Planning & Zoning Board

Thursday, July 17, 2025

RE: Driven Brands, INC. care of John P. Slagter, Esq. for Ashley Daly of Take 5 Oil Change,
7041 E. Main Street: Variance

On behalf of the City of Reynoldsburg, EMH&T conducted a preliminary engineering review of the Site Plan for the 7041 East Main Street Project. The Conditional Use Application for this project has been submitted and is currently under review. The property is located on the south side of East Main St, approximately 600 feet east of Briarcliff Road and 800 feet west of Haft Drive. The proposed project intends to construct a Take 5 Oil Change drive-thru. The proposed drive-thru is a part of the Conditional Use Permit Application request submitted to the City. The following summarizes our findings and recommendations with respect to this project.

C2
SITE
LAYOUT

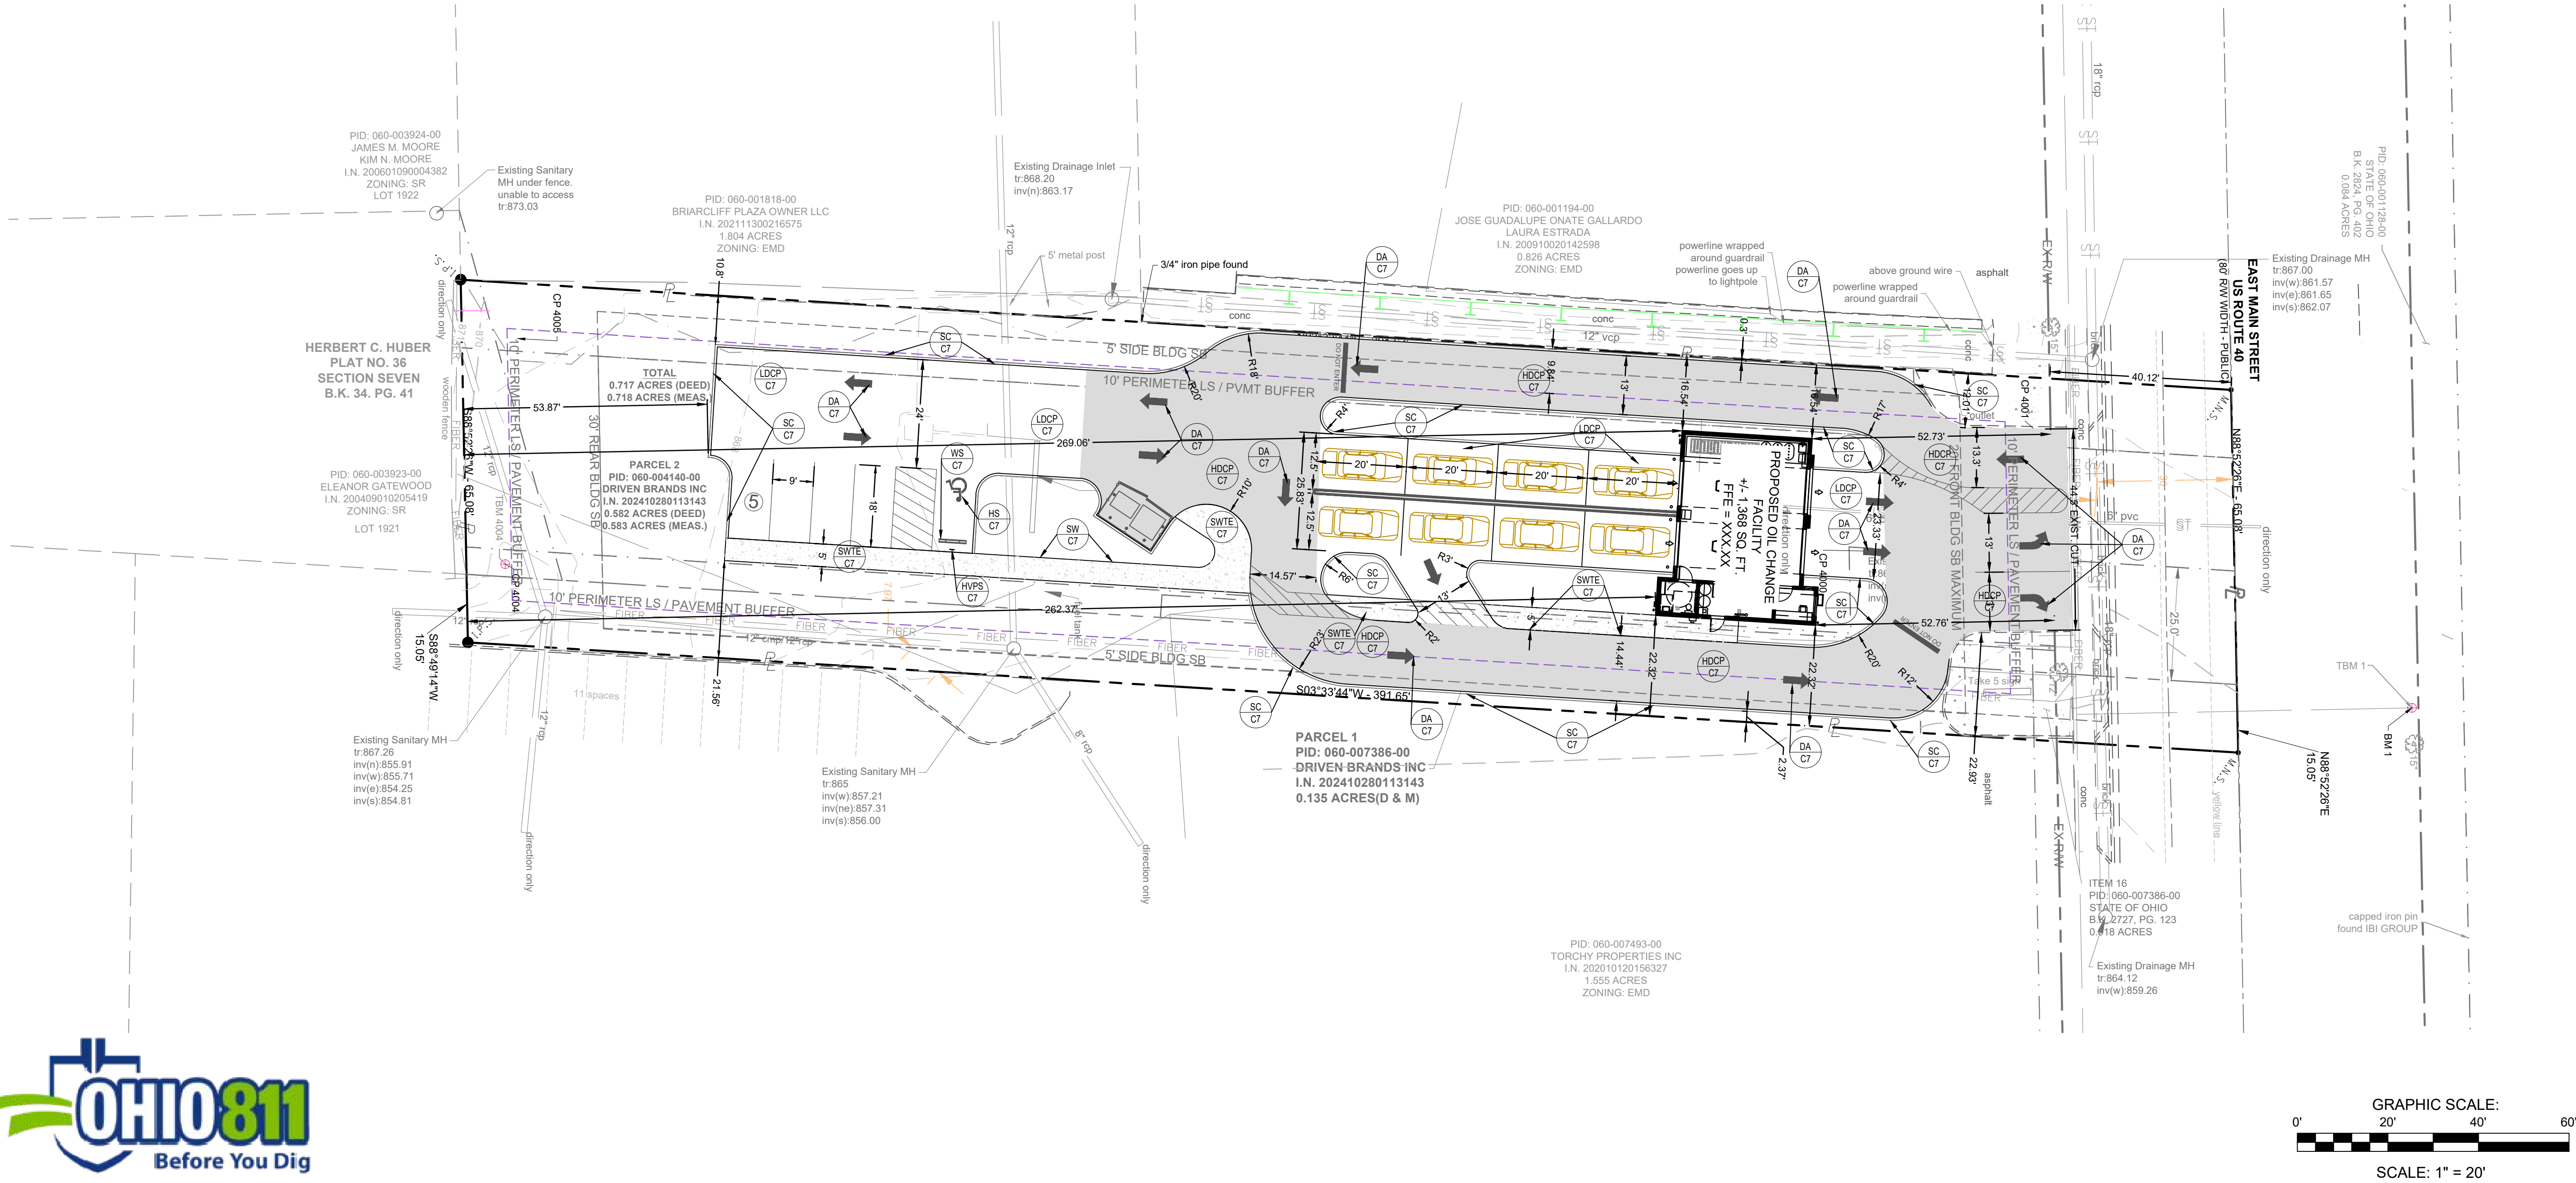
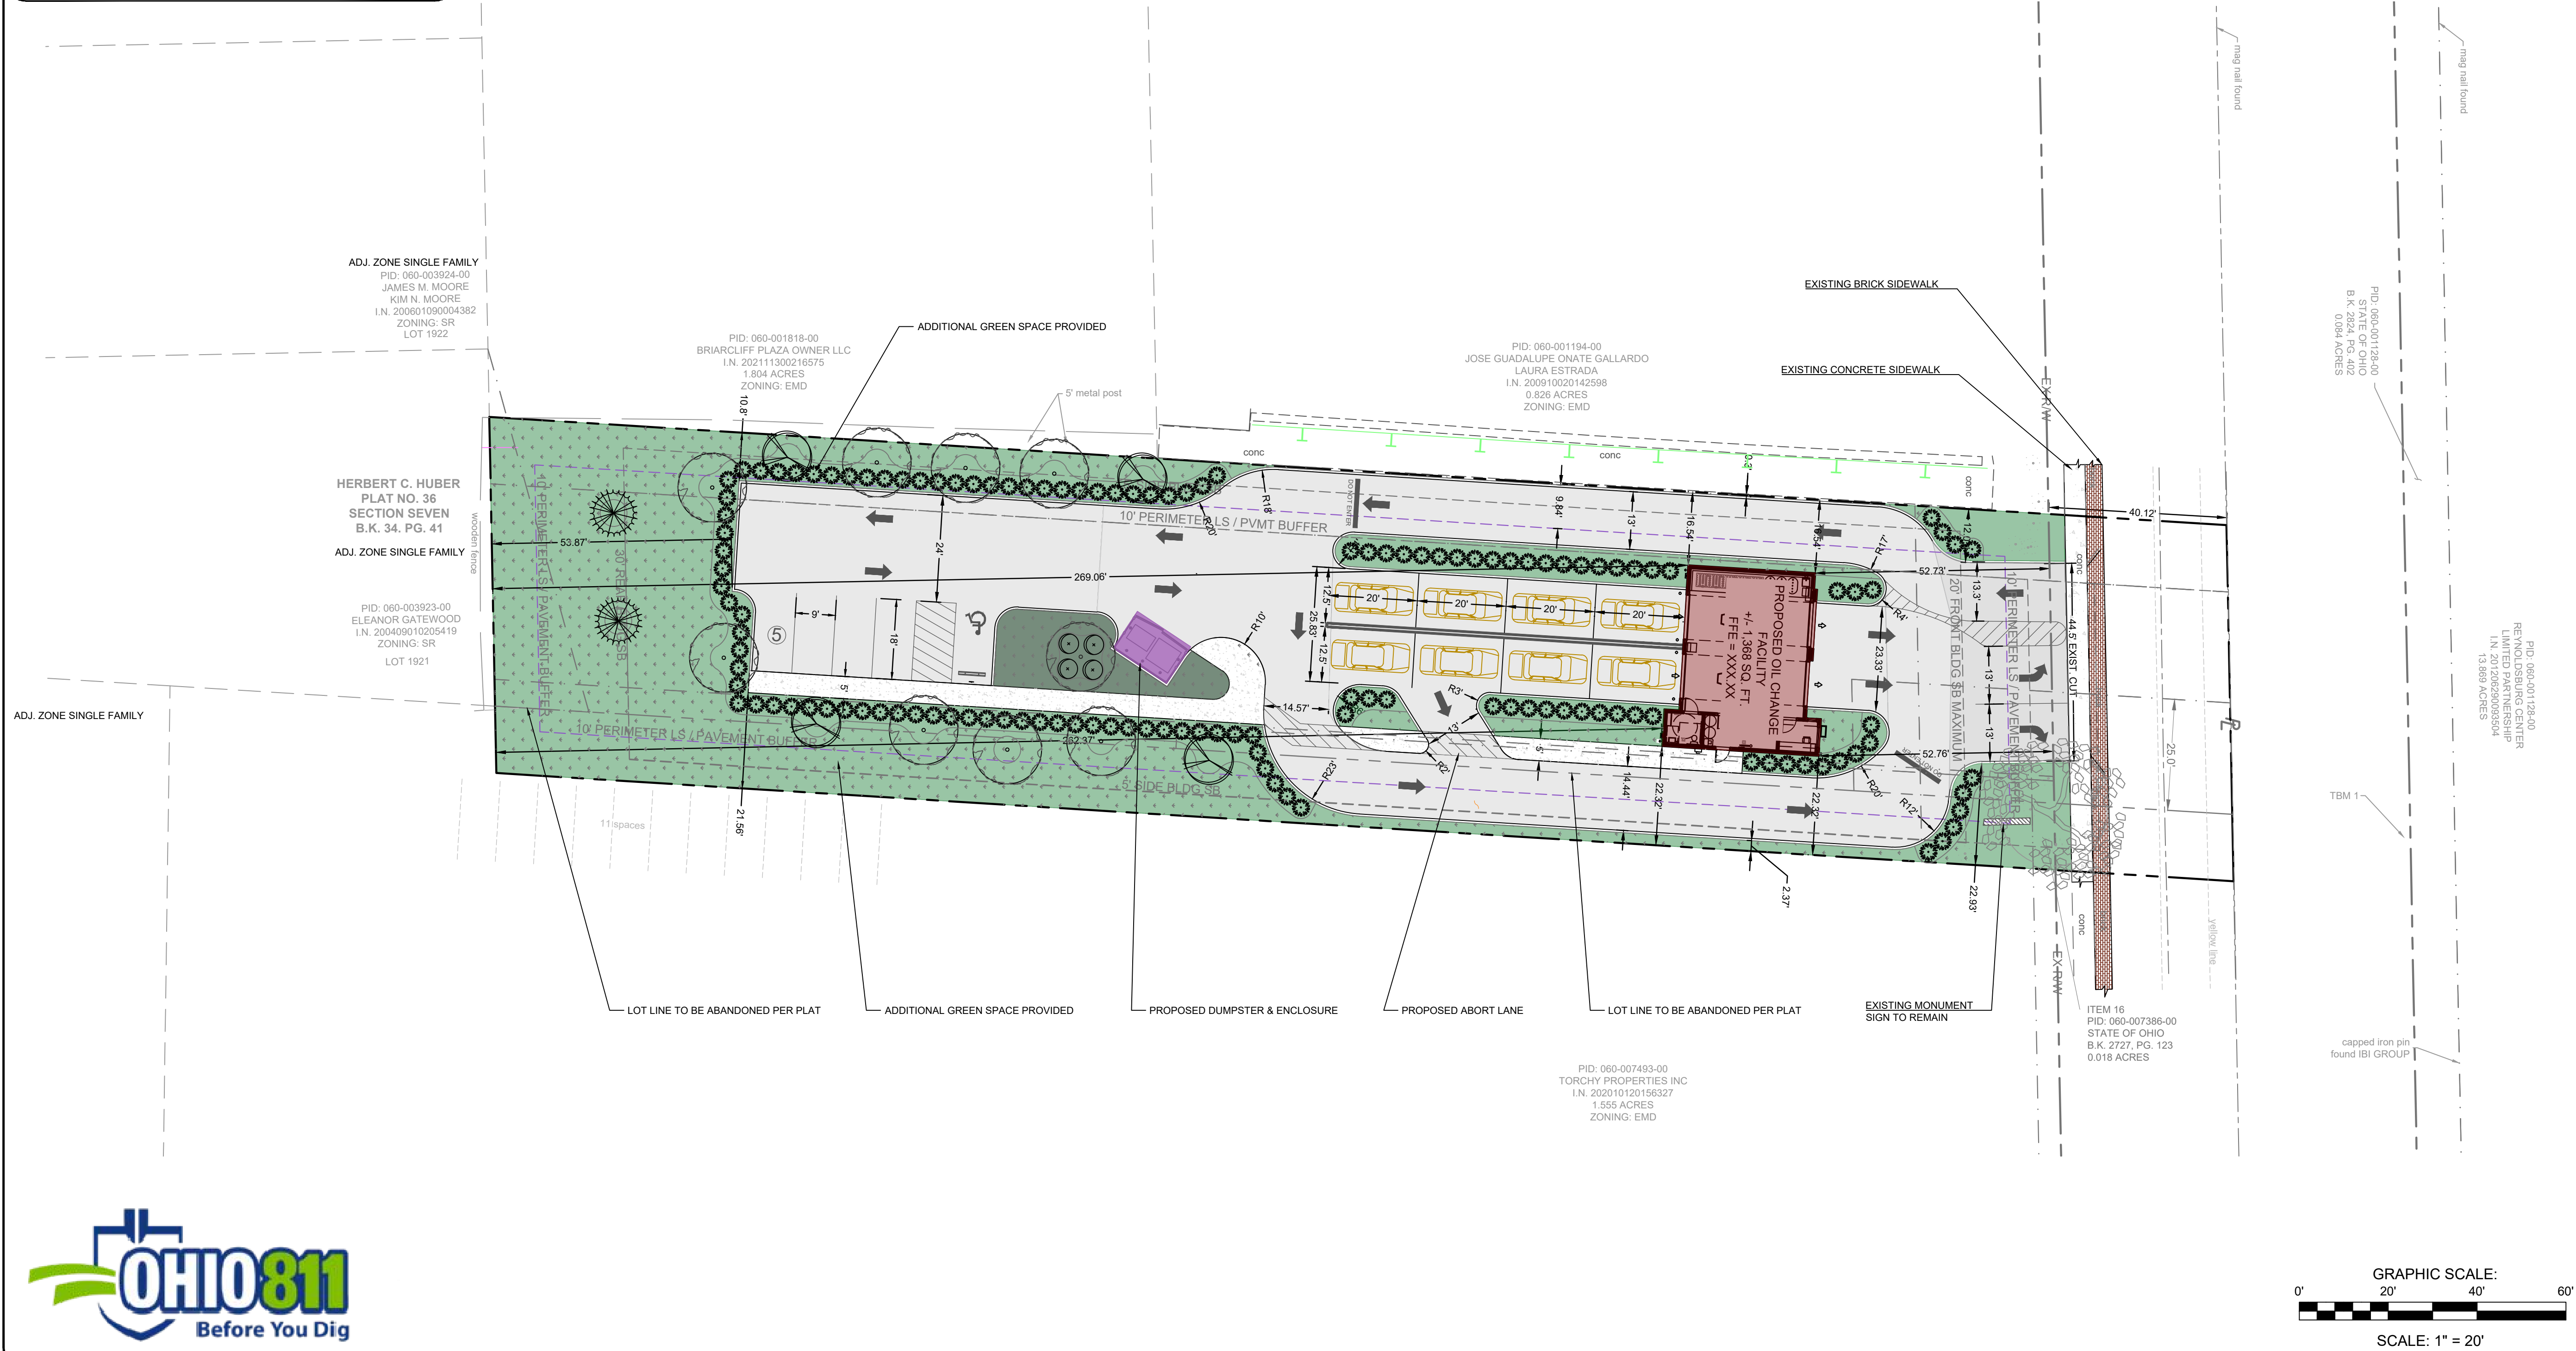
2. Based on EX-B, it appears the proposed oil change facility is a new building.
 - a. Clarify this on the site plan, that you are not saving a portion of the existing building, but in fact removing the existing building and building a new building.

- 8. The Letter of Explanation states that the existing building is approximate 75 feet from the right-of-way.
 - a. If a new building is being built, the existing buildings setback does not matter.

- b. The setback of the proposed building to the right-of-way/parcel line needs to be shown on the site plan, so that an accurate setback of the proposed building is identified on the site plan, and if a variance is needed, requested.

- 9. The Letter of Explanation states a variance is being requested to reduce the building height to a minimum of 19 feet. The site plan states the minimum building height is 20 feet.

- c. The proposed building has been revised to meet the minimum building height requirement at 22', and therefore, no variance is requested here.
- 10. The drive-thru portion of the site, where 2 lanes of 4 cars are shown stacked, does not have an abort/escape lane.

- i. This also means all zoning code requirements have to be met. Section 1107.11.A
 - b. The enclosed site plan has revised to clarify that the existing building will be demolished and a new building will be constructed, see page 3.

- e. The setback of the proposed building to the right-of-way/parcel line is shown on pages 2 and 3 of the Site Plan.
 - f. The enclosed narrative statement identifies the variances sought and the specific Code Sections.

1. All 9 variance standards will also have to be addressed for this variance request.
 - b. An abort/escape lane has been added to the middle of the eastern stacking lane as shown in the Site Plan. Applicant is requesting a variance to the extent that another abort/escape lane is required for the western stacking lane. Additionally, if it is determined that the location of the abort lane in the eastern stacking lane requires a variance, Applicant is requesting a variance for that as well.
